City of Hamilton

PUBLIC WORKS COMMITTEE REVISED

Meeting #: 21-016
Date: November 1, 2021
Time: 1:30 p.m.
Location: Due to the COVID-19 and the Closure of City Hall (CC)

8.1.	Hamilton Water Leak Detection Program (PW21063) (City Wide)	82
8.2.	Update to Hamilton's Solid Waste Collection Design Guidelines for Developments (PW21061) (City Wide)	107

2 29 HARRIET - PROPOSED HAMMERHEAD IMPACTS
A0.03 1:150

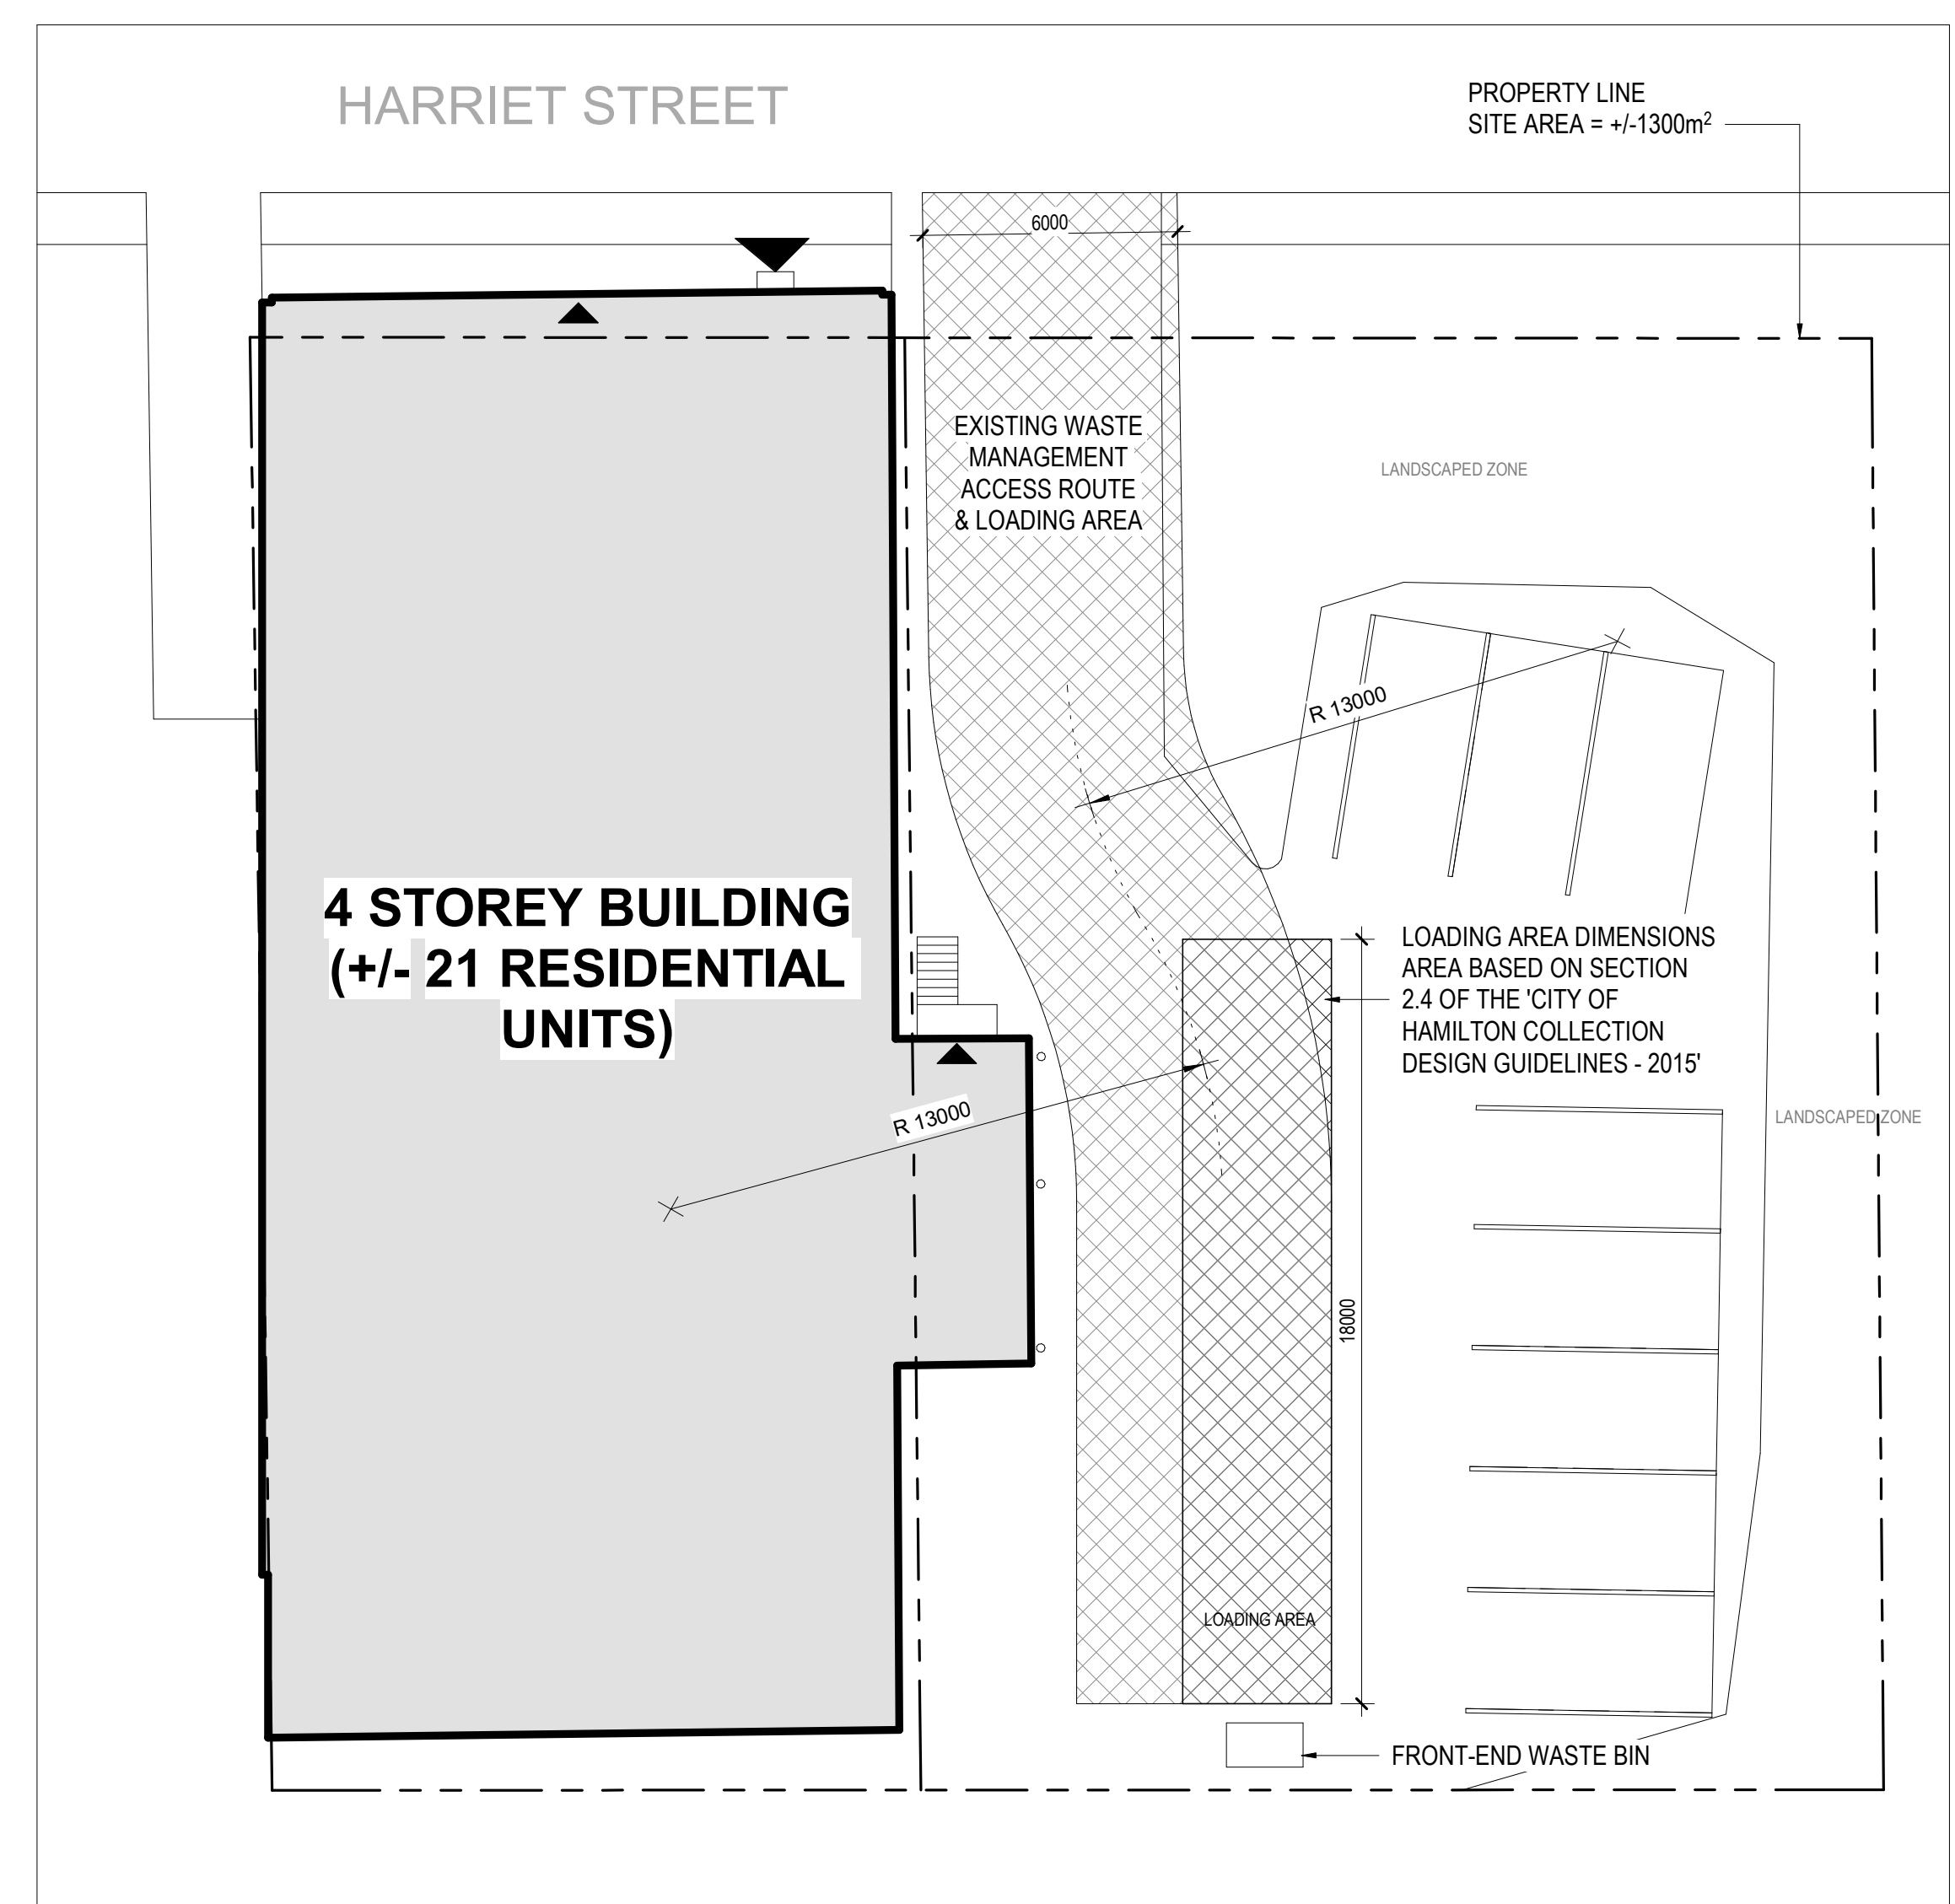
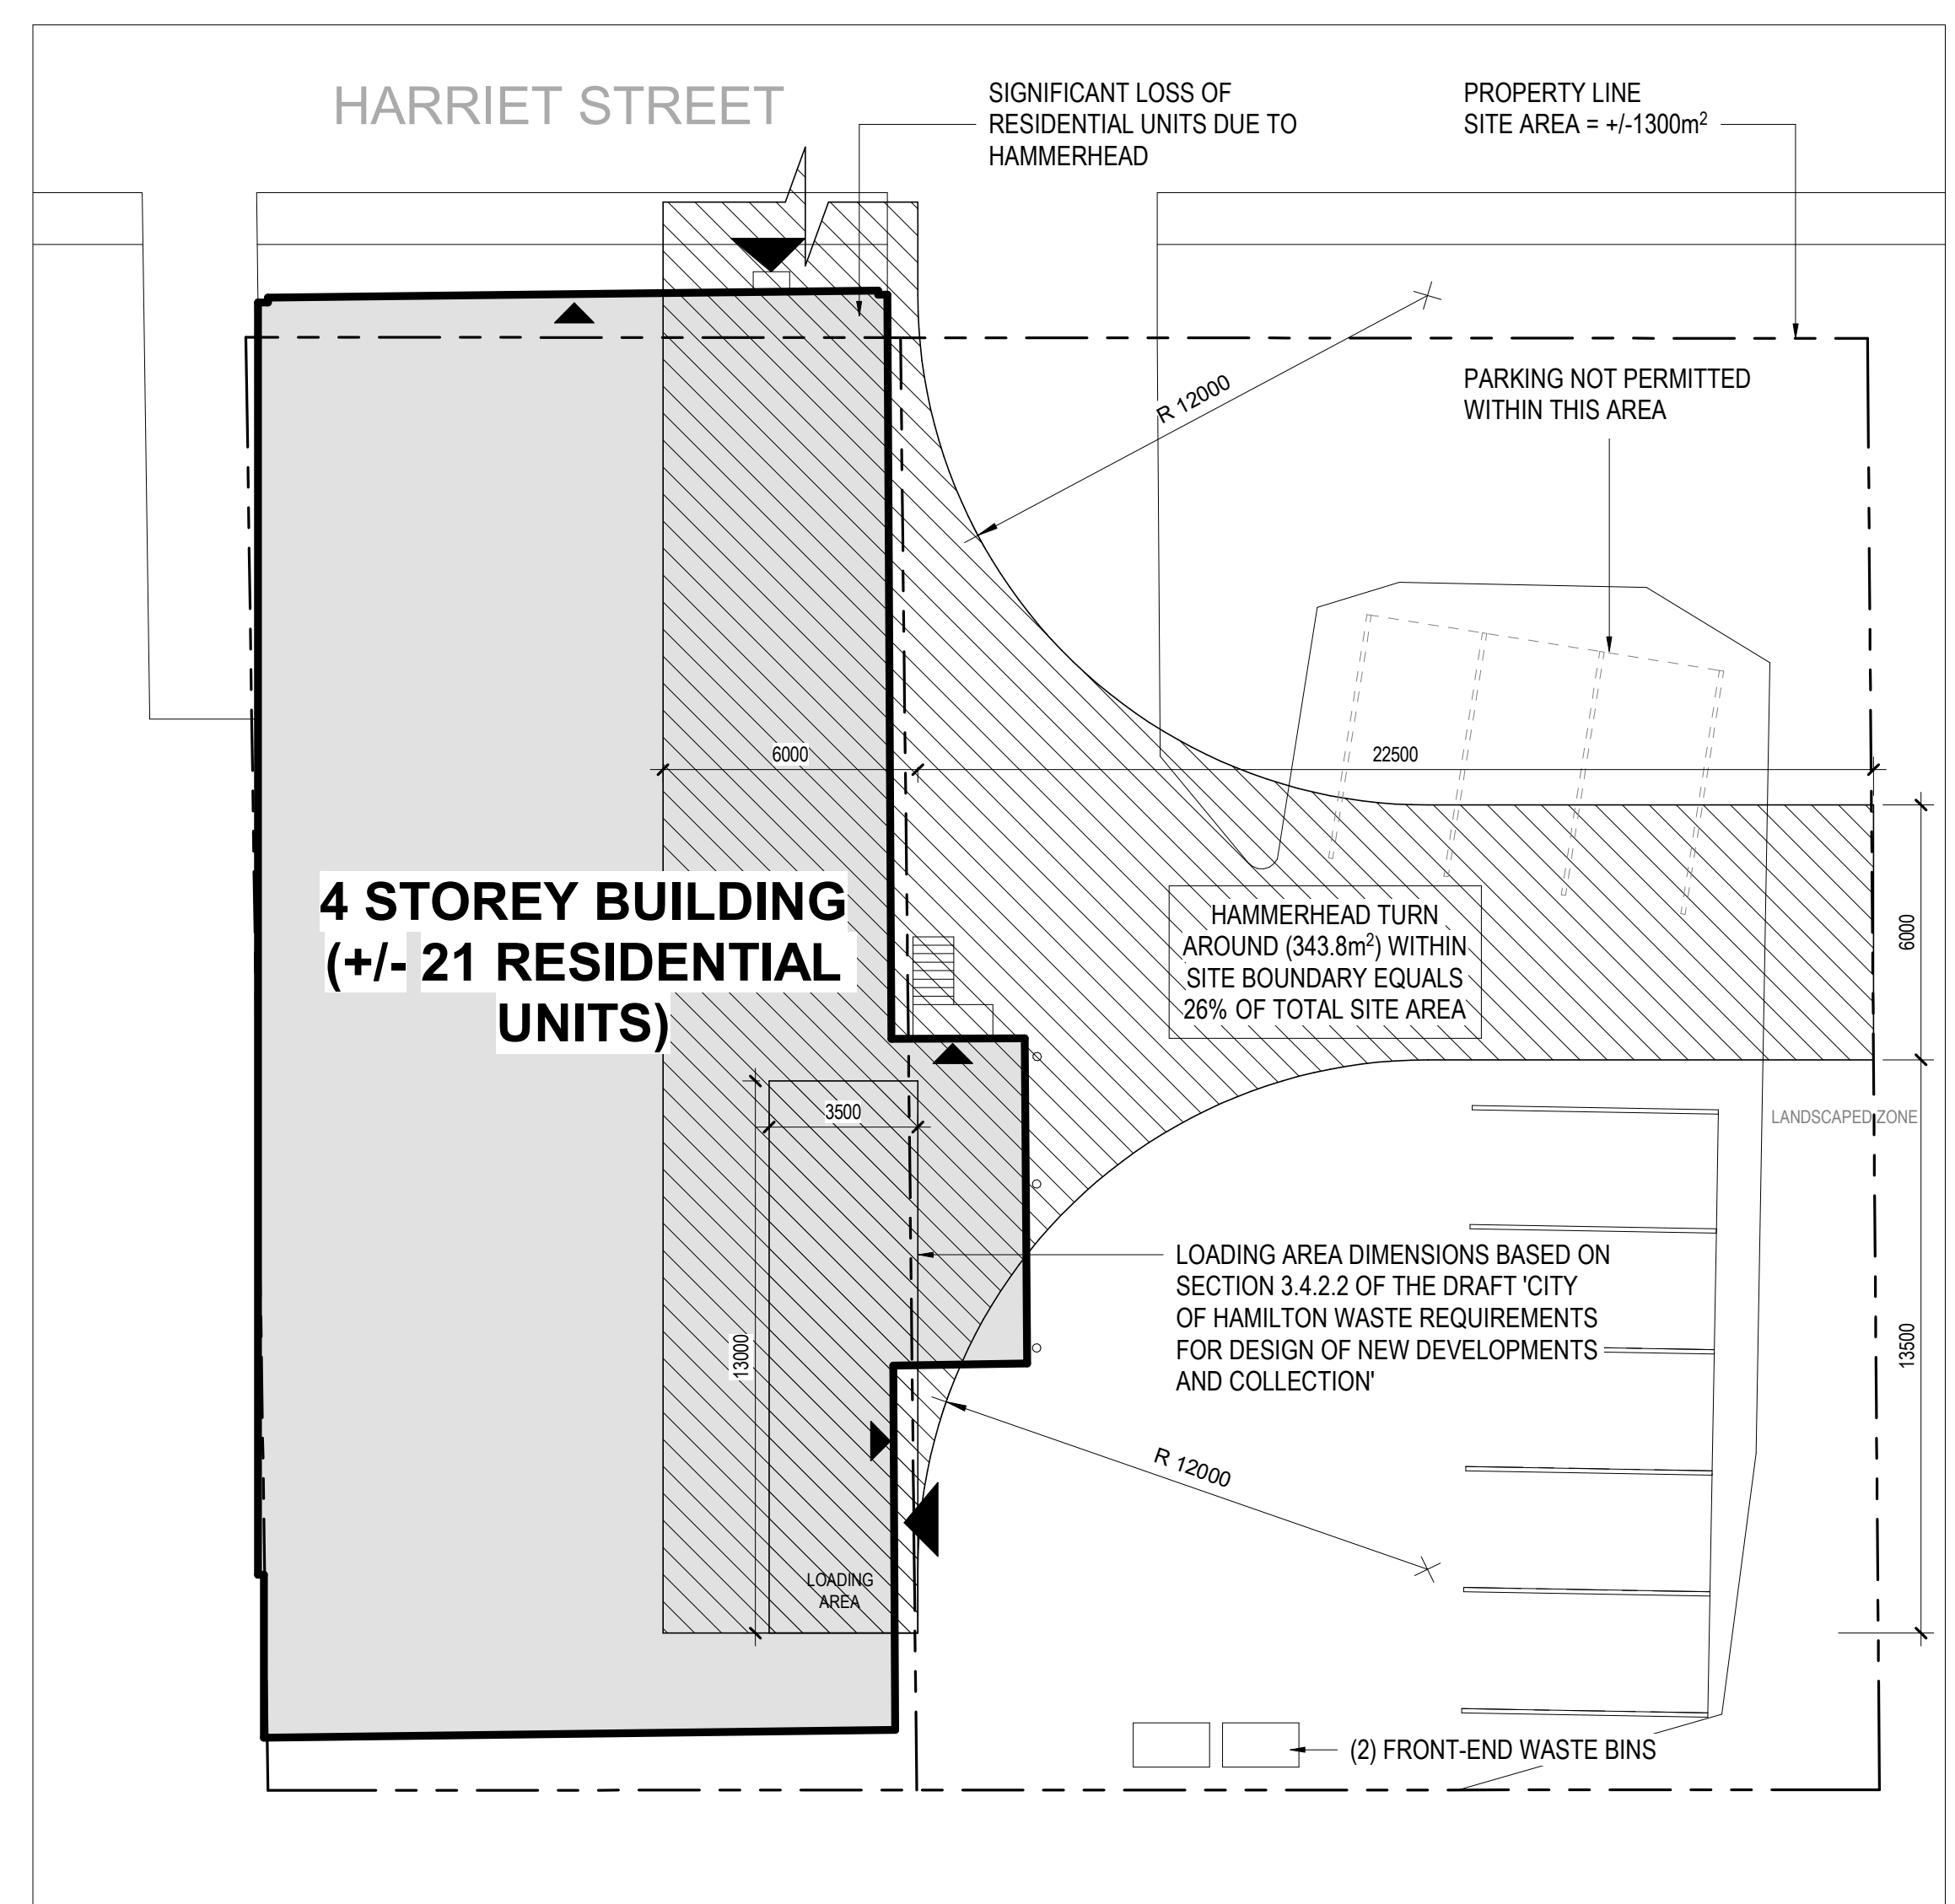
- THE CURRENT PARKING CONSTRAINS WOULD ENCOUNTER SIGNIFICANT LOSS OF PARKING CAPACITY DUE TO HAMMERHEAD SPACE REQUIREMENTS
- REDUCTION OF BUILDING AREA AND UNITS DUE TO HAMMERHEAD SPACE REQUIREMENTS (12 UNITS LOST)
- GOALS FOR INTENSIFICATION WOULD BE REDUCED DUE TO PROPOSED HAMMERHEAD REQUIREMENTS

TOTAL LOSSES:

POTENTIAL FOR 21 UNITS IS REDUCED TO 9 UNITS BASED ON BUILDING AREA CLEAR OF HAMMERHEAD

MAJOR DEMOLITION TO EXISTING BUILDING WOULD BE REQUIRED
